# HISTORIC LANDMARKS COMMISSION

**JANUARY 11, 2018**

Subject: **REQUEST FOR CERTIFICATE OF APPROPRIATENESS HLC2017-024**, submitted by Roy Burden, agent for Greenhouse Properties, property owner, for after-the-fact replacement of 29 windows at 500 W. Washington Street, Zoning Map 34G17, Block A, Parcel 7. The affected area is further identified as being located in the Suffolk Voting Borough, zoned CBD, Central Business District, and HC, Historic Conservation Overlay District.

## STAFF REPORT

# HLC2017-024 500 W. Washington Street Windows

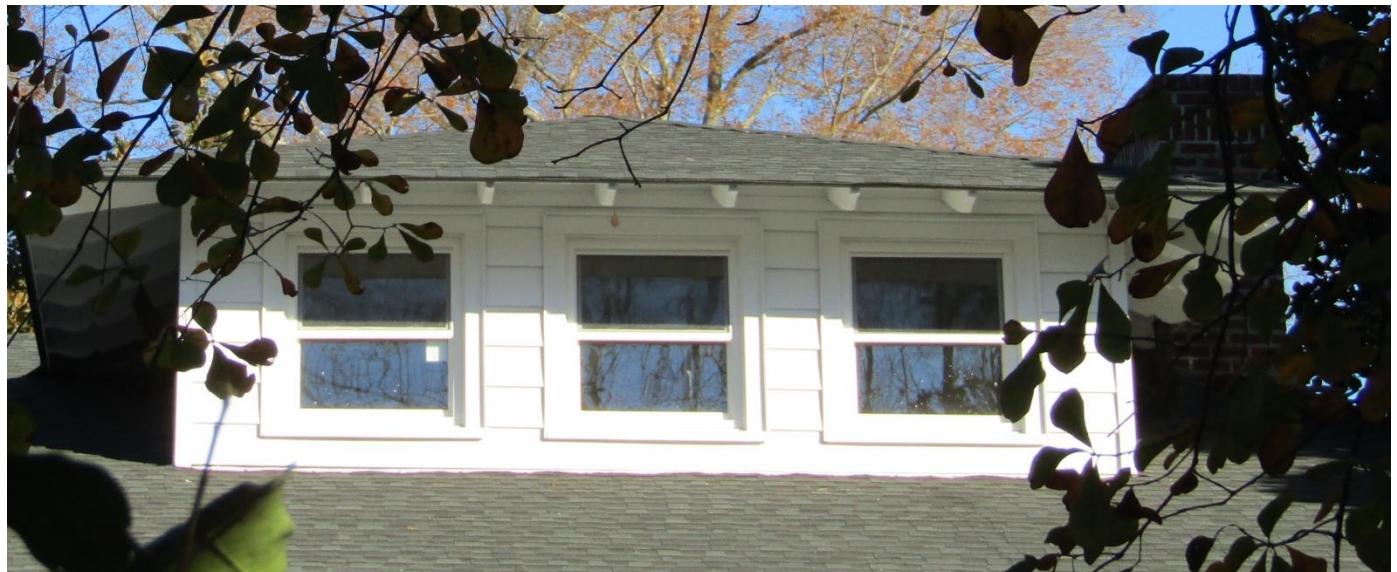
As noted, the applicant is requesting after-the-fact approval for the replacement of 29 windows that were a combination of double-hung sash and casement, full divided light, wood windows. The largest windows were 12/12 double-hung sash windows, many of which were located on the south (front) and east sides of the house facing West Washington and Pender Streets. The remainder of the windows included three 10/10 sash windows in the front dormer, smaller 6/6 sash windows on the sides and rear of the structure, 12 light casement windows on the basement level, and smaller 9 light casements strategically placed where the wall height did not allow for larger windows. All of these windows were original to the structure and typified the American Craftsman style through the use of natural material and multiple lights in the upper sashes and casement windows. The use of multiple lights in the lower sashes was not as common, making this house a unique example of the Craftsman style in Suffolk.

Of the 29 windows the applicant has replaced, three (3) were located on the front (south) elevation facing West Washington Street and eleven (11) were located on the east elevation facing Pender Street. Two original sash windows remain on the front façade and three casement windows remain on the east façade. The remaining fifteen (15) windows that have been replaced are on the north and west elevations, with the majority having been located on the west elevation facing the structure at 504 West Washington Street. The corner location of the structure and placement of the house on the lot make all sides of this structure visible from public rights-of-way, although some views are currently obscured by vegetation. Removal of the existing vegetation, which would be permitted by the Guidelines, would lead to high visibility of the windows on all façades.

important character defining features that are apparent when observing the original windows. Specifically, the original windows featured multiple light muntin configurations with a noticeable muntin depth, thickness and exterior exposure that are easily evident from the street. The replacement windows that have already been installed lack the material, configuration, and details of the original windows, which places them in conflict with Chapter 4. Section C.3, of the Suffolk Historic District Design Guidelines. Additionally, the Secretary of Interior's standards do not recommend "Changing the historic appearance of windows through the use of inappropriate designs, materials, finishes, or colors which noticeably change the sash, depth of reveal, and muntin configuration; the reflectivity and color of the glazing; or the appearance of the frame." Prior to the replacement of the original windows, no 1/1 sash or single pane casement windows existed on this structure; therefore, none of the replacement windows match the configuration of the original windows that they replaced.

Photographic evidence regarding the original windows, which are prominent features throughout the structure, indicate that many could potentially be restored instead of replaced. The original windows provided the detail and craftsmanship one would expect of a contributing American Craftsman bungalow. Fine carpentry and detailing were defining features of the style and the Arts and Crafts movement that inspired it, where good design was believed to be the result of the inherent beauty of natural materials and handcrafting. As such, the treatment of character defining features, such as windows, is vital for maintaining the historic integrity of this structure. The vinyl windows that have been installed are of an inappropriate material, profile, and configuration, and are inconsistent with the standards of the Suffolk Historic District Design Guidelines or the Secretary of Interior's Standards for Rehabilitation.

1. Deny the after-the-fact installation of twenty-nine (29) full divided light, double-hung sash and casement wood windows with one over one (1/1), double-hung sash vinyl windows.
2. Replace all previously installed vinyl windows with wooden windows compatible in design, profile, and configuration with the windows original to the structure. Previously removed casement windows shall be replaced with new casement windows compatible in design, profile, and configuration with the windows original to the structure.
3. Retain existing original windows on the south and east façades. Repair and repaint wood white if necessary.
4. All wooden window elements shall be painted white.
5. No further exterior improvements permitted without the issuance of a Certificate of Appropriateness.
